HISTORIC AND DESIGN REVIEW COMMISSION

HDRC CASE NO: 2021-479
ADDRESS: 411 N MONUMENTAL
LEGAL DESCRIPTION: NCB 1373 BLK 1 LOT 35
ZONING: RM-4, H
CITY COUNCIL DIST.: 2
DISTRICT: Dignowity Hill Historic District
APPLICANT: Pegy Brimhall/Figrd, LLC
OWNER: Monica Naves/Vergel Constructions, LLC
TYPE OF WORK: Construction of a 1-story, residential structure with a detached rear accessory structure
APPLICATION RECEIVED: September 21, 2021
60-DAY REVIEW: Not applicable due to City Council Emergency Orders
CASE MANAGER: Edward Hall

The applicant is requesting a Certificate of Appropriateness for approval construct a 1-story, single family residential structure on the vacant lot at 411 N Monumental, located within the Dignowity Hill Historic District. The applicant has also proposed to construct a rear accessory structure.

1 SITE PLAN
G0.01 SCALE 3/16" = 1'-0"

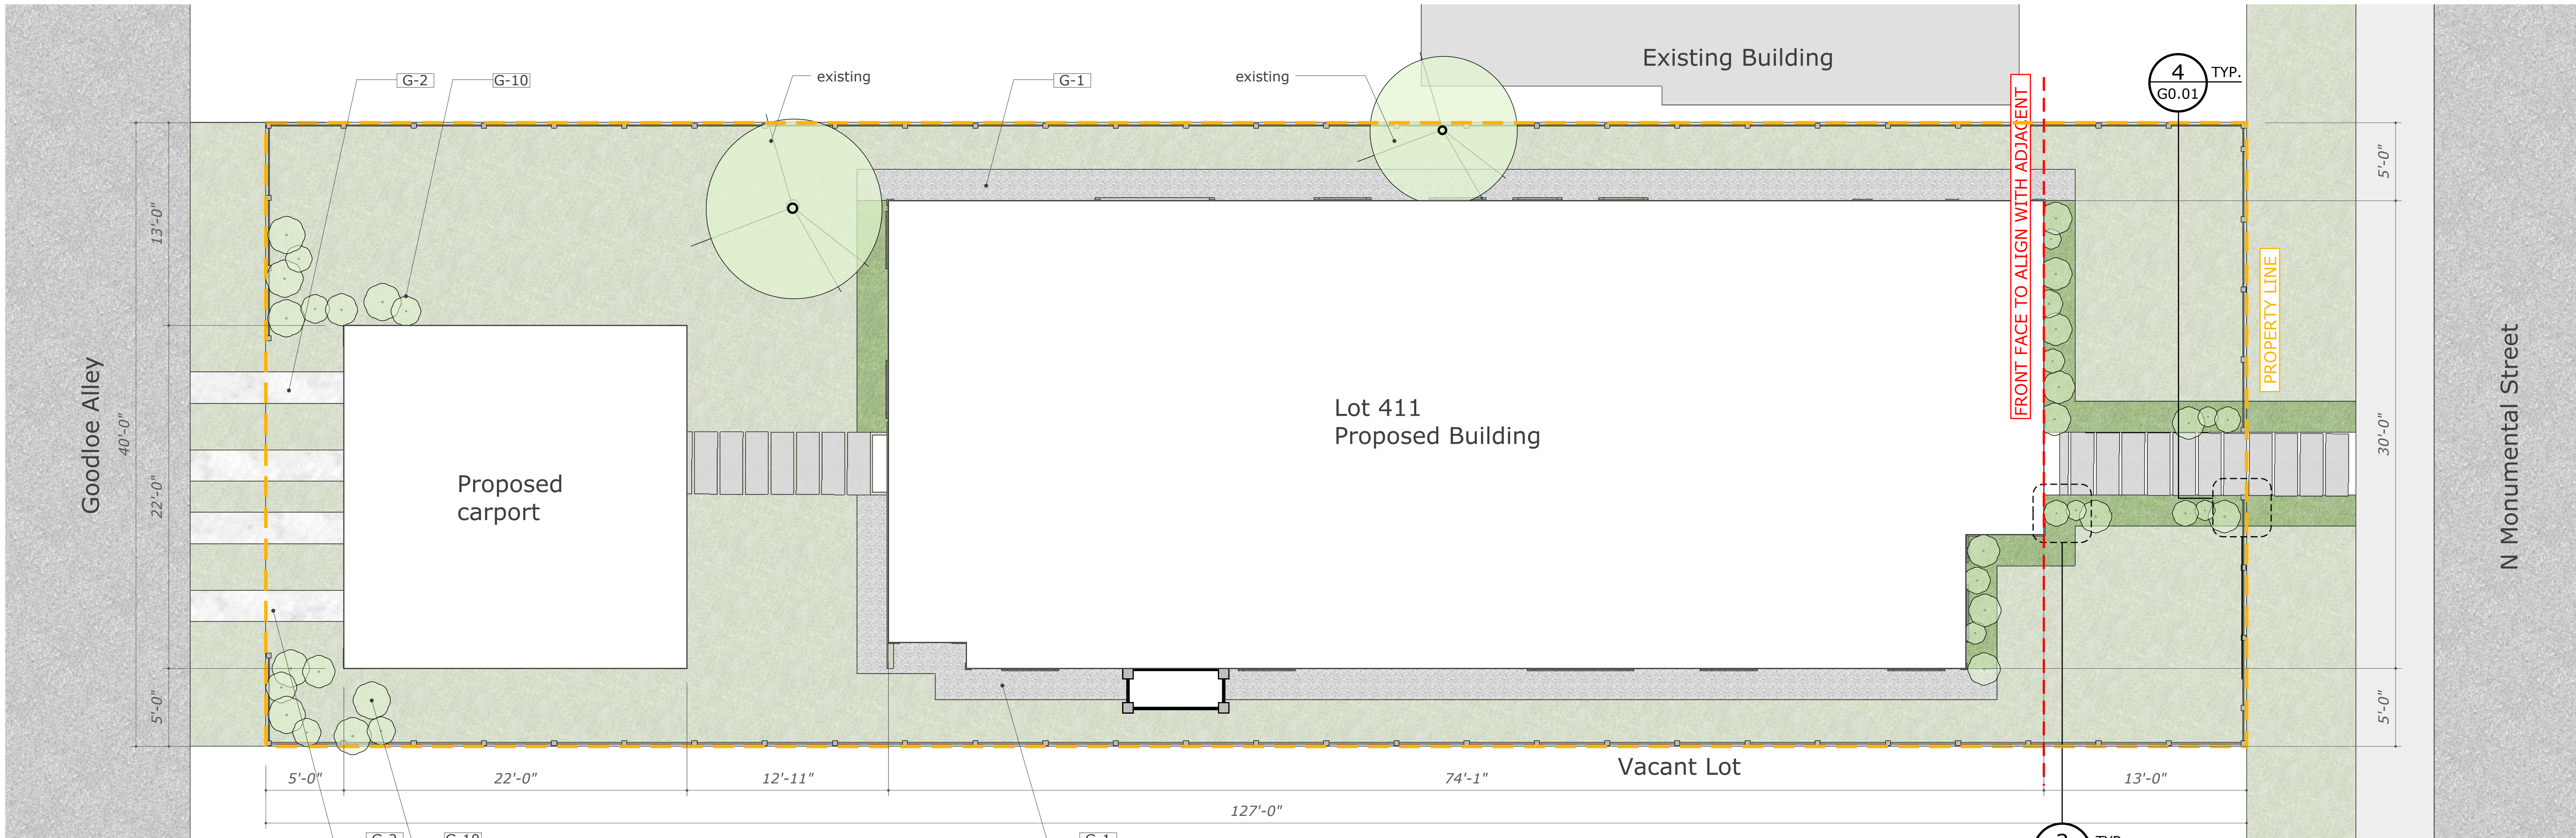
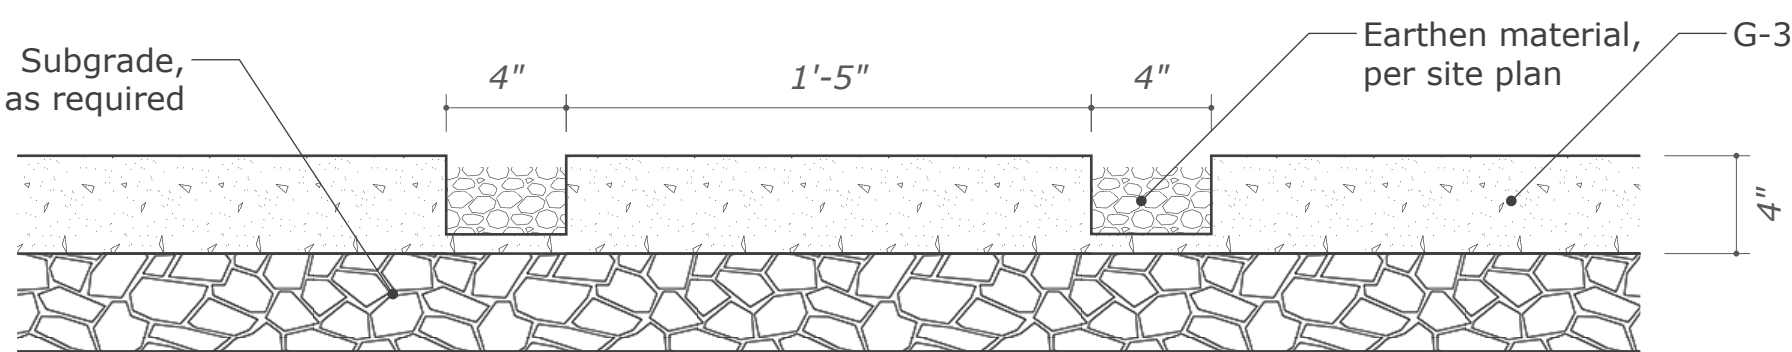
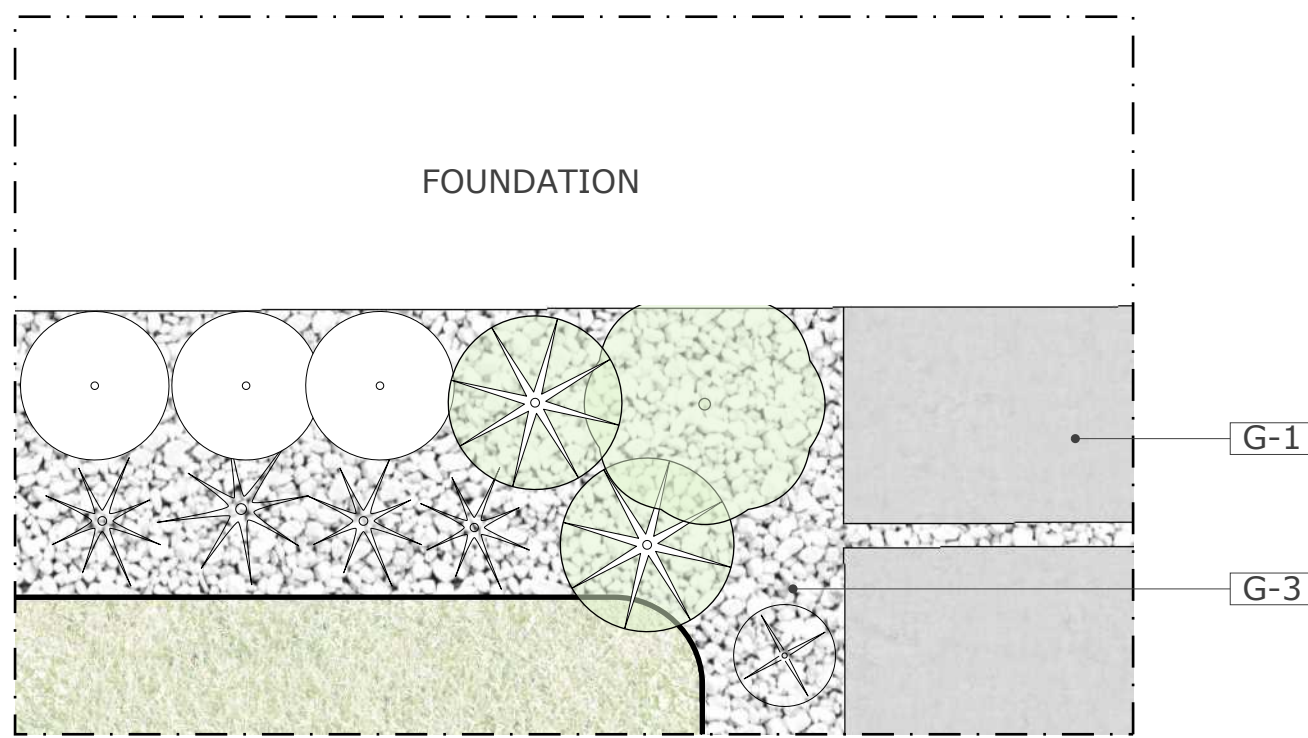
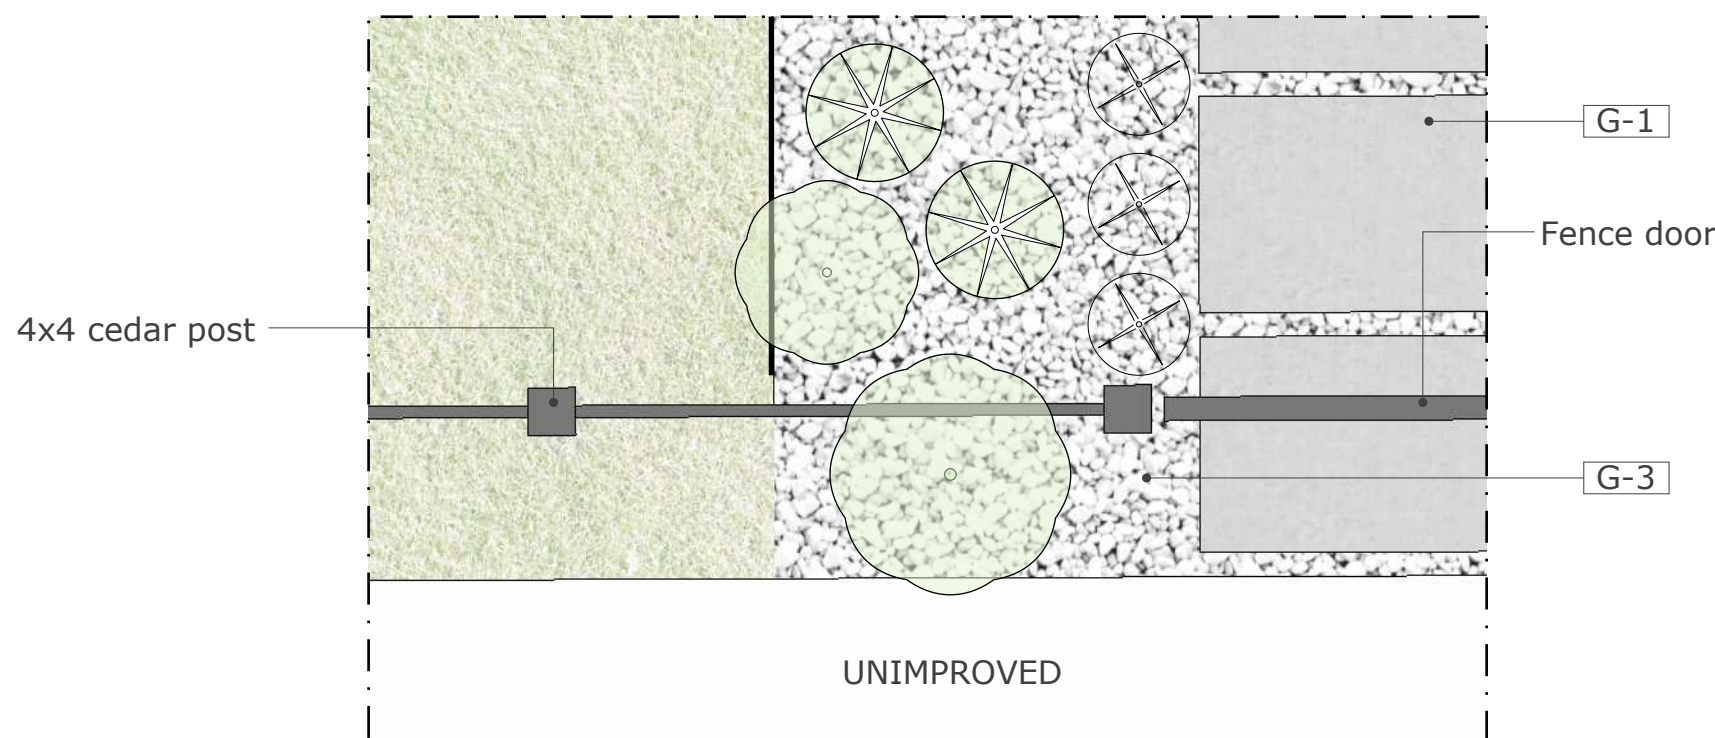
- q. WALKWAY – The applicant has proposed a concrete paver walkway to lead from the front porch to the sidewalk at the public right of way. Staff finds the proposed walkway to be appropriate; however, staff finds that it should be poured concrete and feature three to four feet in width, per the Guidelines for Site Elements.

- r. LANDSCAPING – The applicant has submitted a detailed landscaping plan noting planting and landscaping materials. Generally, staff finds the proposed landscaping to be appropriate.

- s. FENCING – The applicant has noted the installation of fencing on site to include both hog wire fencing and cedar privacy fencing. Staff finds both fencing proposals to be appropriate; however, fencing should not exceed four (4) feet in height within the front yard (in front of the front façade, including the recessed porch). Privacy fencing should not exceed six (6) feet in height.

- t. MECHANICAL EQUIPMENT – The applicant has noted the location of mechanical equipment and has noted that it will be screened by a fence.

- iv. That the proposed front walkway be poured concrete to be consistent with the Guidelines and historic examples found within the district.
- v. That fencing not exceed four (4) feet in height within the front yard (in front of the front façade, including the recessed porch). Privacy fencing is not to exceed six (6) feet in height.

1 N MONUMENTAL STREET ELEVATION
G0.03 SCALE 1/4" = 1'-0"

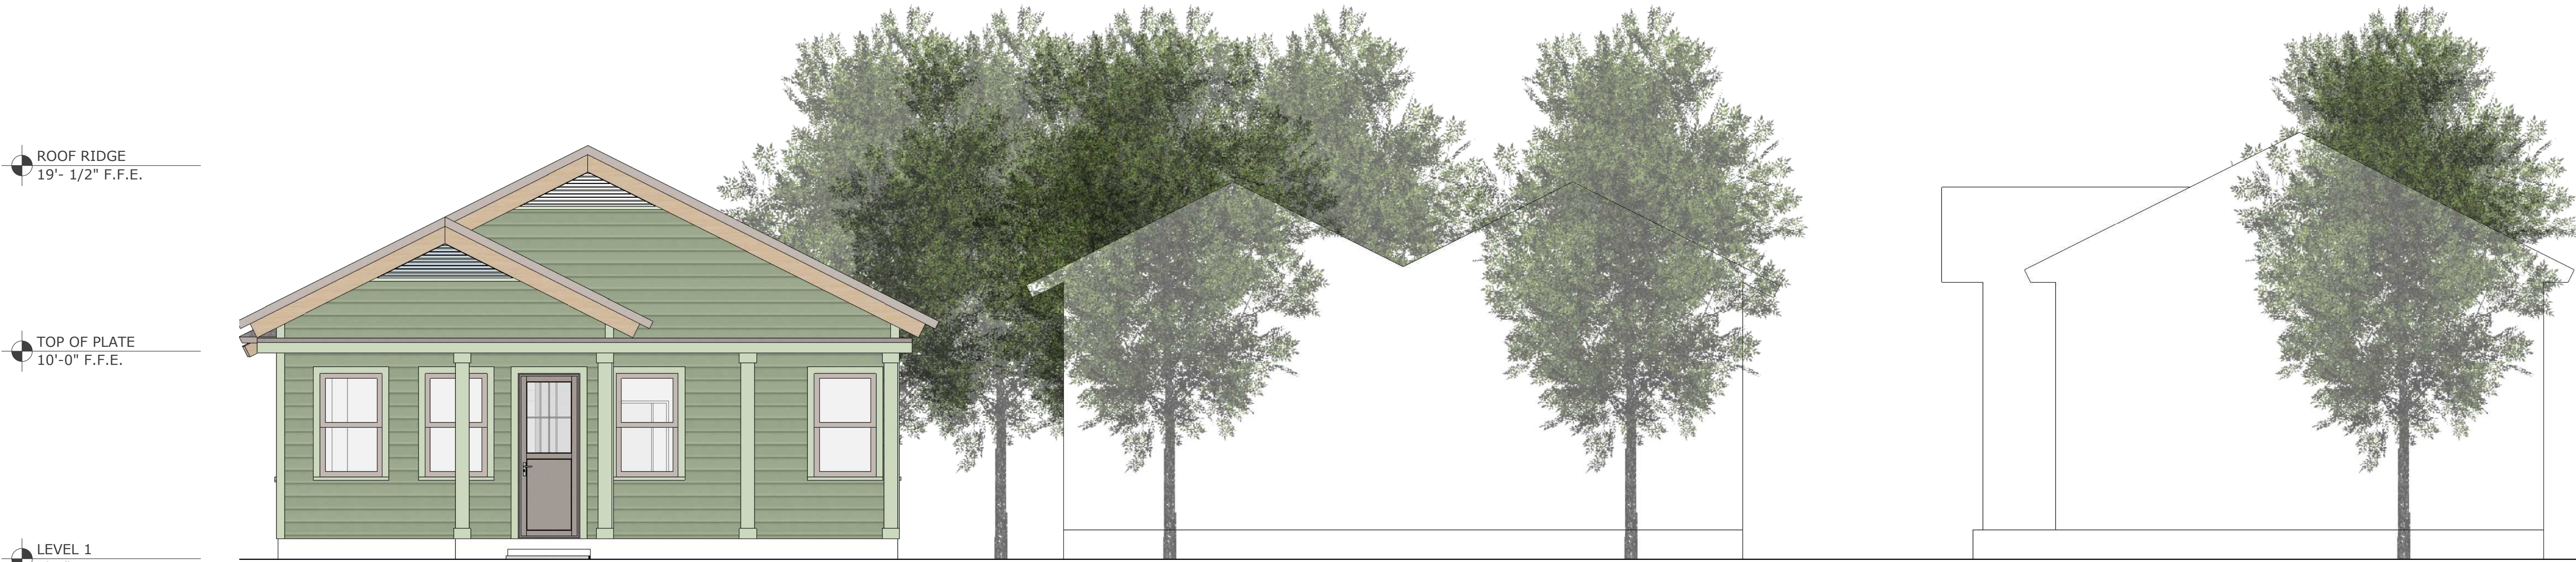
- c. CONTEXT & DEVELOPMENT PATTERN – This lot is currently void of any structures. This block of N Monumental currently features five historic structures on the west side of the block, each with an orientation toward N Monumental. Each of these structures features one story in height.

- d. SETBACKS & ORIENTATION – According to the Guidelines for New Construction, the front facades of new buildings are to align with front facades of adjacent buildings where a consistent setback has been established along the street frontage. Additionally, the orientation of new construction should be consistent with the historic examples found on the block. The applicant has proposed a setback of 13' – 6" from the property line, aligning with the setback of the historic structure to the immediate north (415 N Monumental) and featuring approximately 2' – 6" of less setback from the street as the closest historic structure to the south 405 N Monumental, which features the deepest setback on the block. Generally, staff finds the proposed setback to be

appropriate and consistent with the Guidelines. OHP staff will field verify that the setback is consistent with the Guidelines and that of the neighboring structure at 415 N Monumental.

Sheet Contents:
Elevations

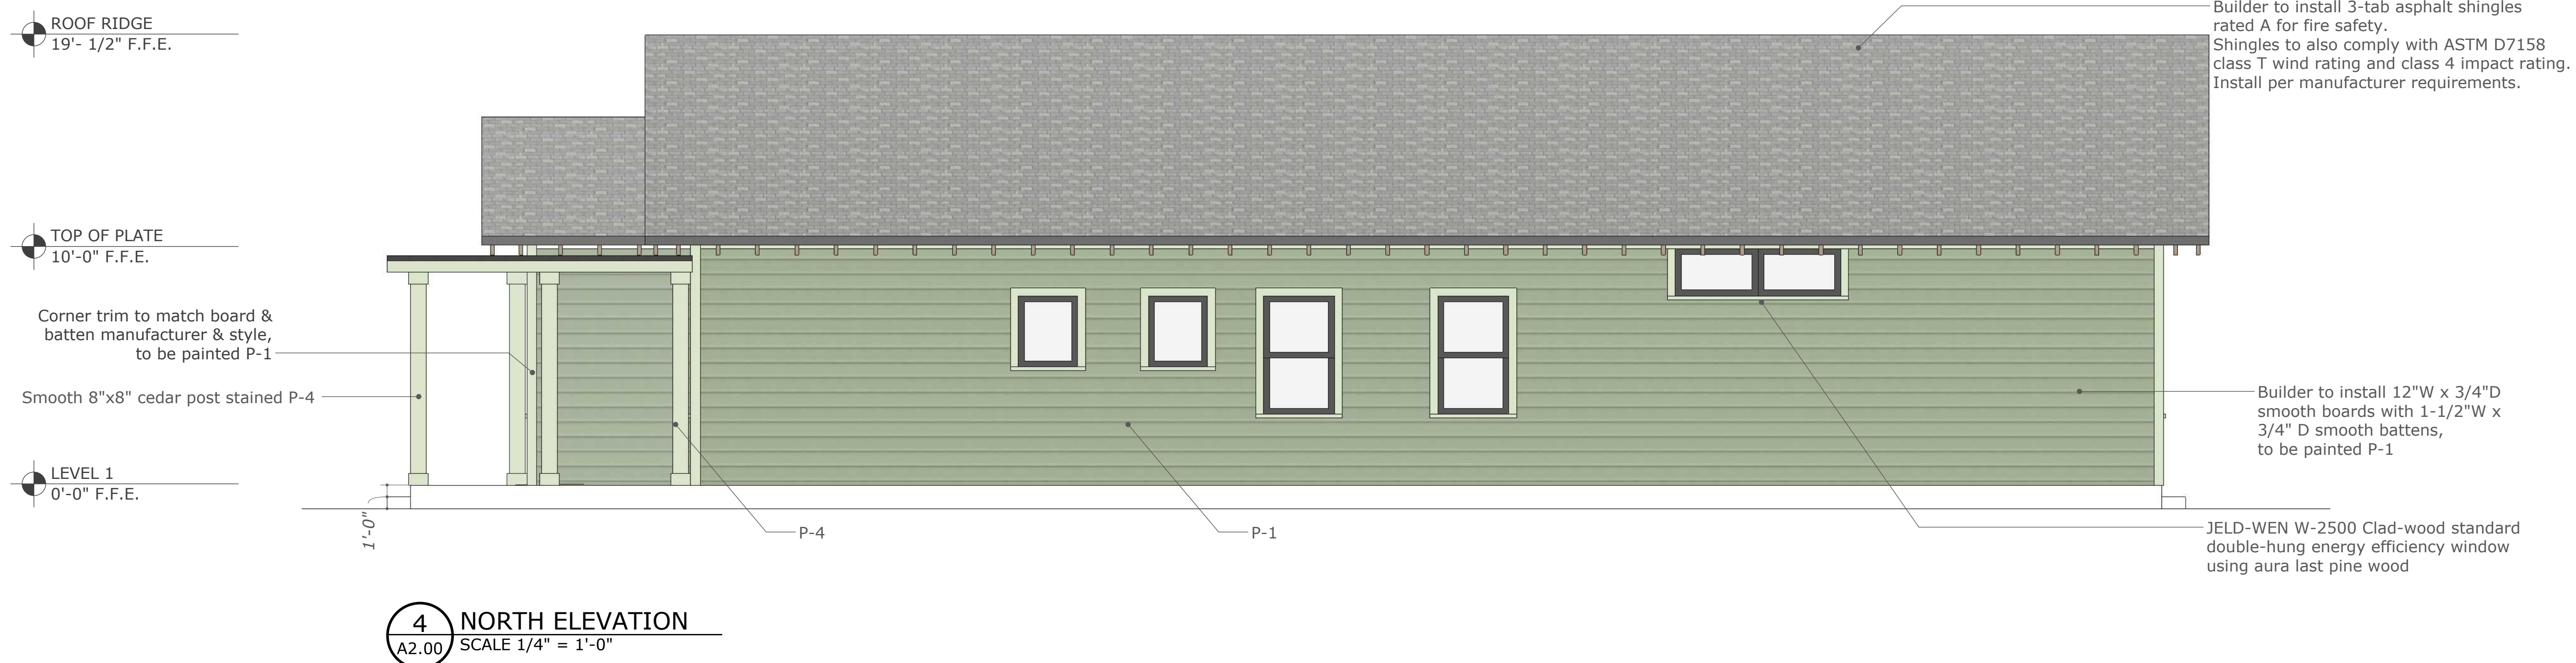
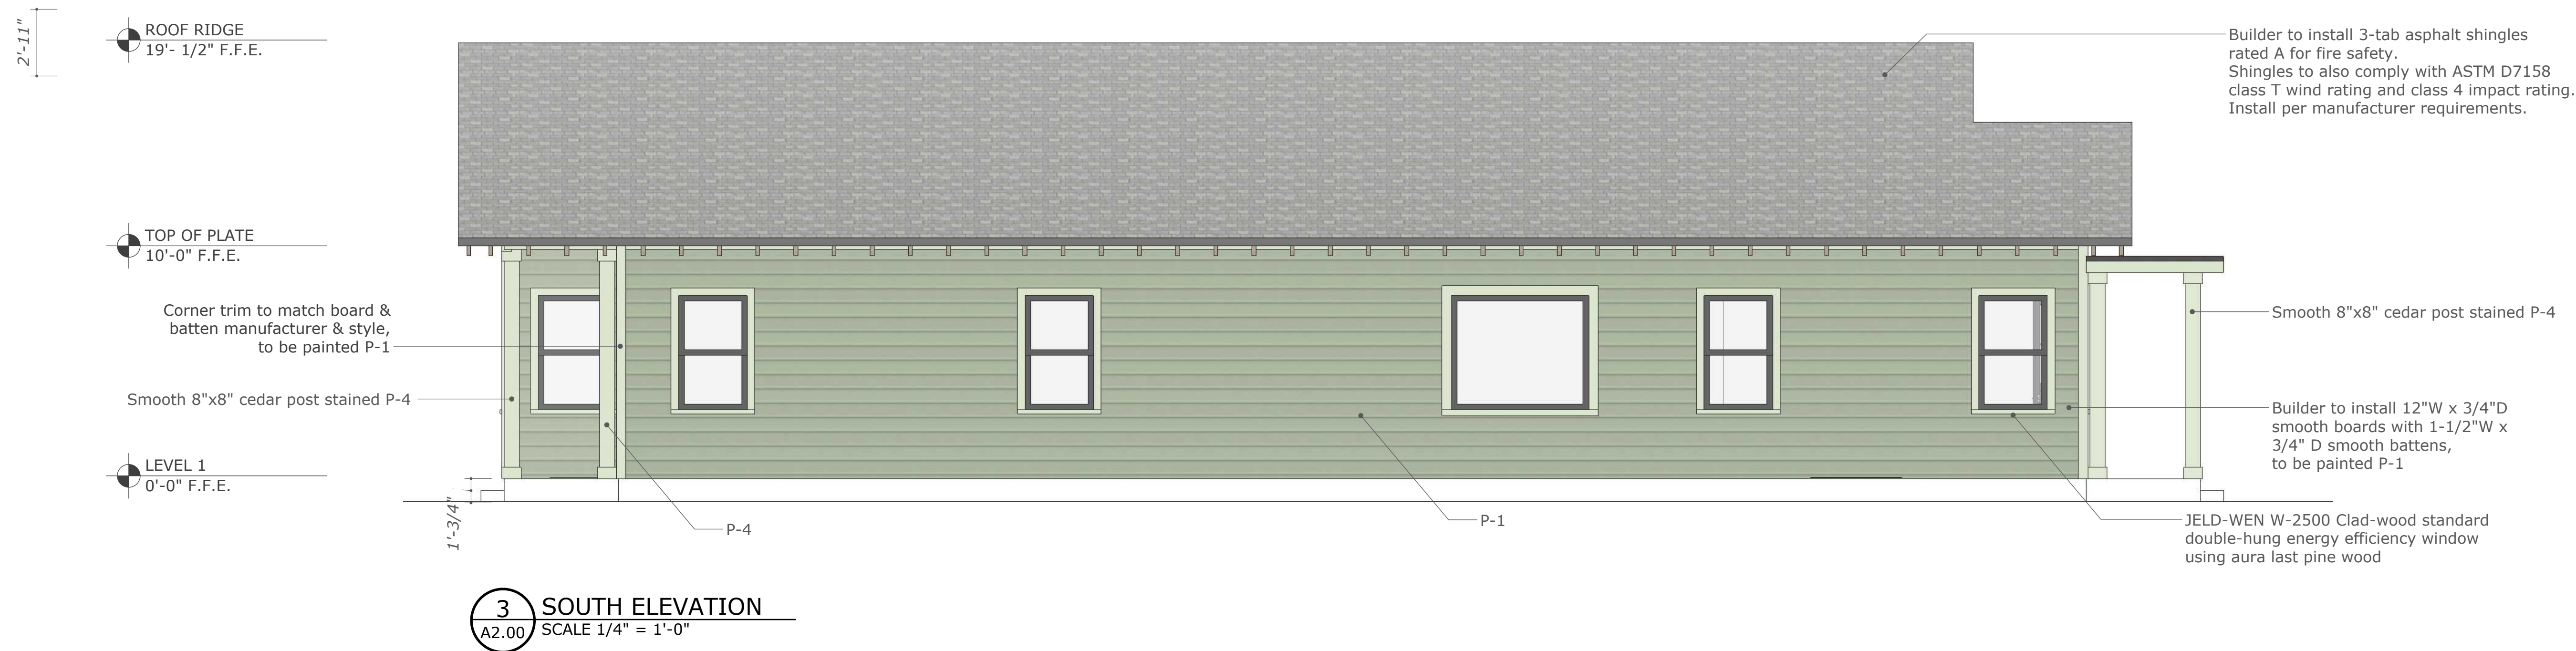
- h. ROOF FORM – The applicant has proposed front and rear facing gabled roofs. Staff finds the proposed roof forms to be appropriate and consistent with the Guidelines.

- i. ROOF FORM (Porch roof) – The applicant has proposed a porch roof that is flat in profile. Generally, staff finds the location of the proposed porch roof to be appropriate; however, staff finds that a flat roof is inconsistent with the Guidelines and examples of historic roofs found within the district. Staff finds that a shed or low hipped porch roof should be incorporated into the proposed porch massing.

- m. FENESTRATION PROFILE – The applicant has proposed fenestration profiles that features a large, picture window (south elevation) as well as fixed windows that feature profiles and head and sill heights that are inconsistent with the historic examples found within the district (north elevation). Staff finds that the applicant should propose fenestration profiles that feature individual windows with operable sashes. Additionally, staff finds that all window openings, and windows should feature traditional heights and widths, and should be separated by mullions and feature individual window openings with windows that feature operable top and bottom sashes in a one over one profile.

- n. FENESTRATION PROFILE – The applicant has proposed for façade locations to be void of fenestration, specifically on the north elevation. Staff finds that additional window openings should be added on the north elevation.

- iii. That the non-traditionally sized windows on the north and south elevations be modified to feature sizes and profiles that are consistent with those found historically within the district. These include the large picture window in the dining room, the two square windows in the bathroom , and the horizontal mater bathroom window. Additionally, staff finds that additional fenestration should be added to the north elevation.

- vi. That a shed or low hipped porch roof should be incorporated into the proposed porch massing, as noted in finding i.
